World Forum for Harmonization of Vehicle Regulations**Working Party on Noise and Tyres**

Tyres: Draft UN Regulation on studded tyres**Proposal for a draft new UN Regulation on the uniform provisions concerning the approval of studded tyres with regard to their snow performance****Revision 1****Submitted by the Task Force on Studded Tyres***

Figure 1:

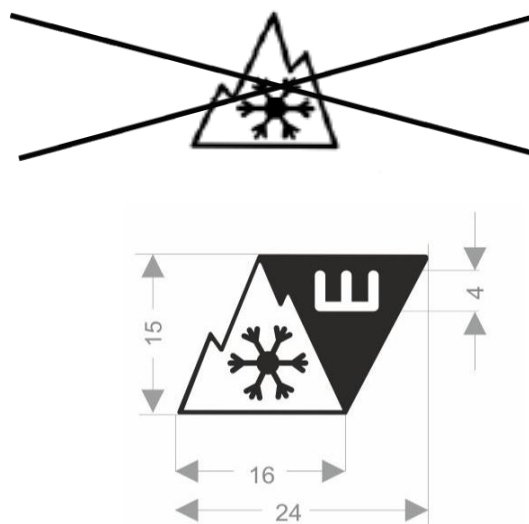
- 4.1. All tyres constituting the type of studded tyre shall be marked as prescribed by either UN Regulation No. 30 or 54, as applicable.
- 4.2. In particular tyres meeting the requirements of paragraph 6.1. below, shall bear:⁴
 - 4.2.1. The Snow Grip Marking **for Studded Tyres as defined below** (also referred to as "Alpine" symbol or "3 peak mountain with snowflake" symbol).

Pictogram definition of "Snow Grip Marking **for Studded Tyres (Alpine Symbol)**"

Minimum 156 mm base and 15 mm height.
